UNITED STATES
NUCLEAR REGULATORY COMMISSION

SUBJECT: SUMMARY OF JANUARY 19, 2000, PUBLIC MEETING WITH THE
NUCLEAR ENERGY INSTITUTE (NEI) REGARDING SIGNIFICANCE
DETERMINATION PROCESS TOOLS FOR ASSESSING RADIATION
PROTECTION PROGRAMS

The purpose of this meeting was to discuss stakeholder comments submitted by NEI (letter dated December 29, 1999) on the occupational and public radiation safety significance determination process (SDP) and inspection procedures that were published in the *Federal Register* on July 26, 1999 (64 FR 40394). NEI provided copies of comments from this letter specific to the occupational and radiation safety SDPs and the inspection process (i.e., access control to radiological significant areas, ALARA planning and controls, and radioactive materials transportation and Part 61 (see Attachment 1)).

OCCUPATIONAL RADIATION SAFETY (ALARA)

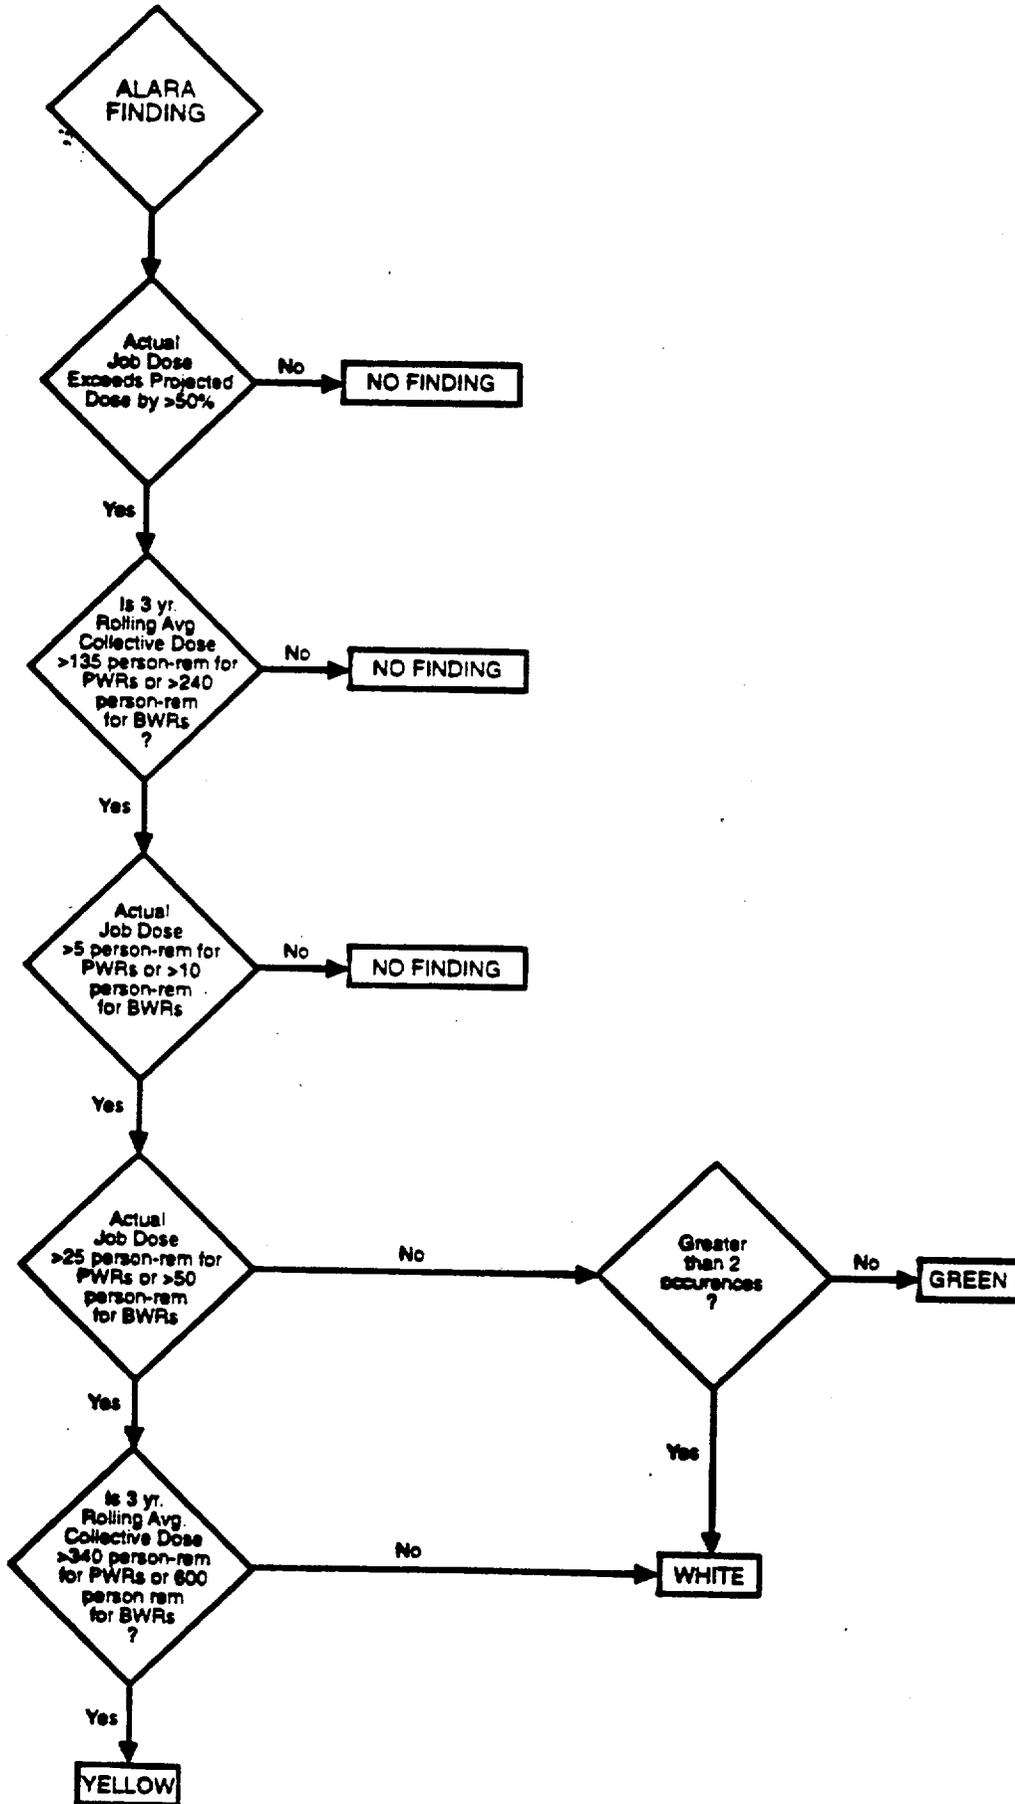
(Page A2-9) The discussion on "ALARA Findings" needs to be updated to reflect the revised SDP. The text is currently based on the 8/10/99 version of the SDP, rather than the most current 11/12/99 version that is shown.

(Page A2-13) Separate "actual job dose" criteria are shown in the fourth and fifth blocks, i.e., for PWRs and BWRs. The job-dose values have been derived as 4% and

20% values of the baseline collective dose values that serve as screening criteria (third block): We do not believe that the approach of using separate criteria for PWRs and BWRs is valid for the job-dose values because they implicitly represent criteria for a determination of relative dose-significance, rather than serving as a performance benchmark. The SDP should employ a single job-dose value in each of the blocks. We suggest that the two values in each block be averaged and rounded to a single digit, yielding 10 rem and 40 rem, respectively.

(Page A2-13) An applicable time period should be specified for the block, "Greater than 2 occurrences?" We suggest that an appropriate time period is "in the assessment period" (e.g., per year). This would be consistent with the approach taken in the public radiation safety SDP for radioactive material control.

4. In the ALARA portion of the Occupational Safety SDP, the staff will relocate the finding screening criteria from the SDP to a guidance document, consistent with program policy.

5. In the ALARA portion of the Occupational Safety SDP, the staff will clarify the basis for the "three or more occurrences" criteria. This is not P,I&R.

6. In the ALARA portion of the Occupational Safety SDP, the staff will review the separate dose levels for reactor classes in the SDP criteria, and revise the SDP as necessary.

OCCUPATIONAL RADIATION SAFETY

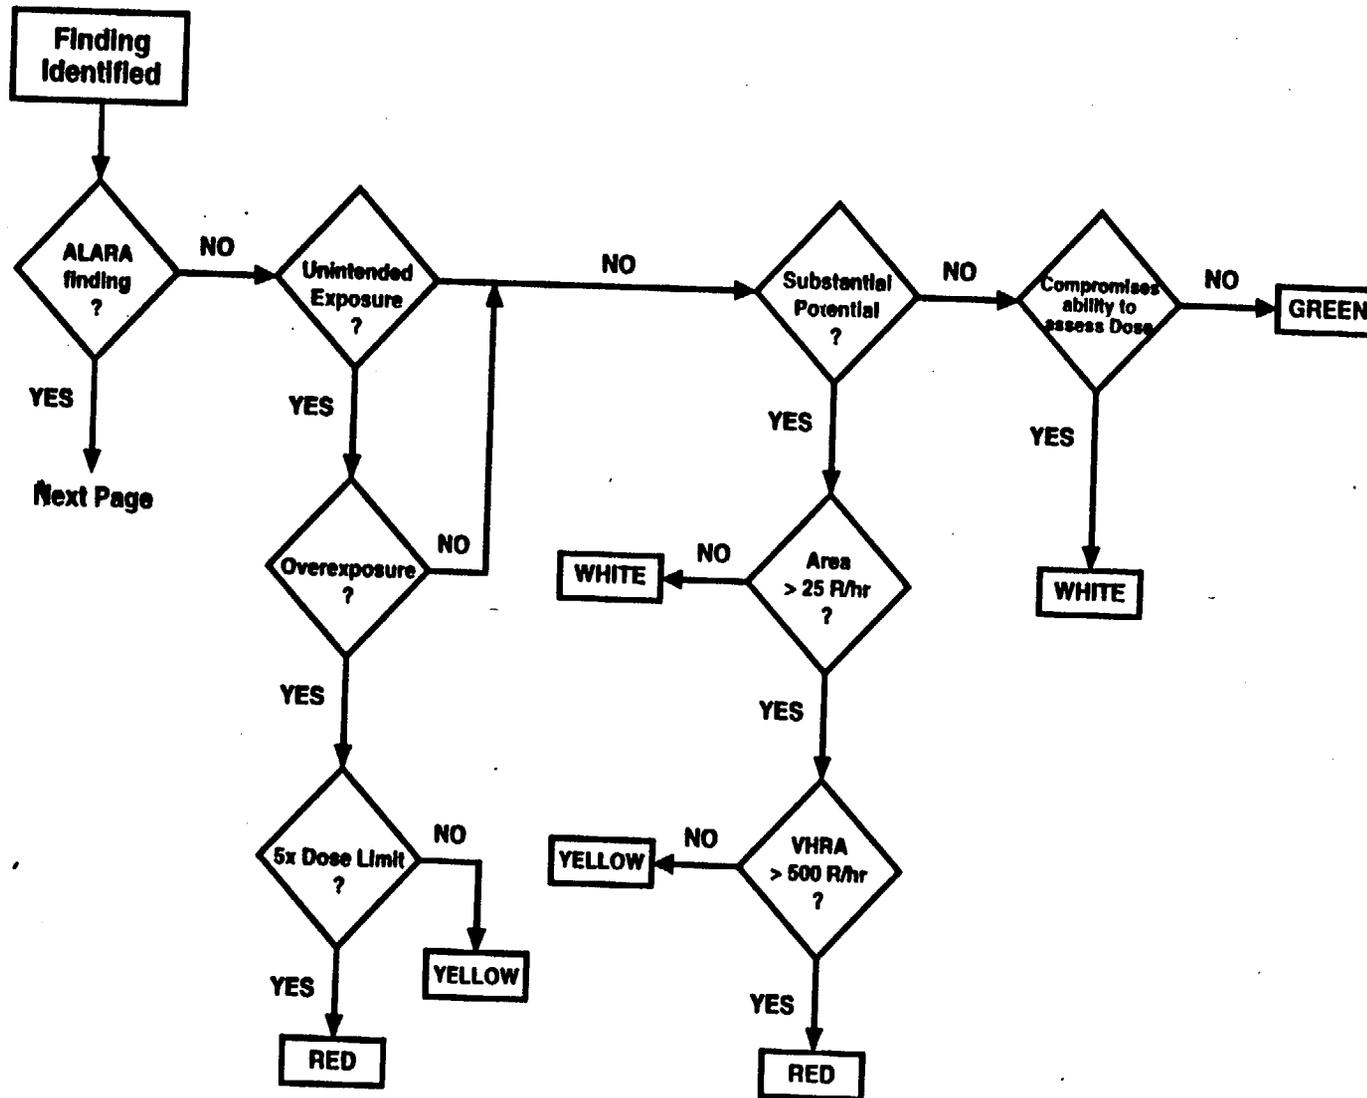
General comment: The process for initial screening of items prior to entering the SDP in the area of occupational radiation safety is not well defined and understood. Explicit screening criteria should be provided similar to the screening criteria that are included in the ALARA SDP. Items of negligible safety significance and little or no potential for any consequence (i.e., with regard to radiation dose to workers) should be screened out as "observations," and not be entered into the SDP process with the result of becoming green findings. We suggest that such criteria screen out items that do not involve any of the following:

(Page A2-10) The SDP should include guidance to clarify that if an "unintended exposure" occurrence has been documented as a PI event, and also does not constitute an overexposure or a substantial potential for overexposure, it will not be documented as a green finding. If already documented as a PI event, the item will already have been placed into the licensee's corrective program, and "double-counting" as a green finding will be non-productive and potentially misleading.

(Page A2-10) The discussion of "unintended exposure" should be revised to improve clarity and consistency with the performance indicator (PI) for occupational radiation exposure control. The first paragraph characterizes any unintended dose that exceeds the exposure that exceeds the criteria in PI as "significant," which is potentially misleading and inconsistent with the SDP.

(Page A2-12) The SDP chart should be revised to improve its internal consistency. The blocks for actual overexposures (i.e., consequences) have been appropriately derived from previous enforcement criteria at 1x and 5x the regulatory limits. In contrast, the blocks for events that involve a potential for overexposure lead to illogical conclusions regarding significance.

For example, an unintended dose occurrence that does not exceed the regulatory limit would be “green,” based on consequence. However, if the event occurred in an area with dose rate levels >25 R/hr, the event would be ranked as “yellow,” which is comparable to an overexposure. Further, the criterion of >25 R/hr lacks a firm basis in either historical performance or in implied significance. Also, the potential “red” finding associated with a “substantial potential” occurrence in a very high radiation area that does not involve an actual overexposure is not consistent with either the consequence-based blocks in the SDP or the bases for criteria in the enforcement policy.

We recommend that the “Area >25 R/hr” block be deleted, and that the finding associated with a “substantial potential” occurrence is “white” if it is not associated with a very high radiation area, and “yellow,” if it is.

7. In the Exposure Control portion of the Occupational SDP, the staff will review the NEI recommendation for the "findings" screening criteria in this area.

8. In the Exposure Control portion of the Occupational SDP, the staff will revise the SDP flow chart to remove the "Unintended Exposure" gate and change the significance outcomes in the "Substantial Potential" branch to make it logically consistent with the rest of the SDP.
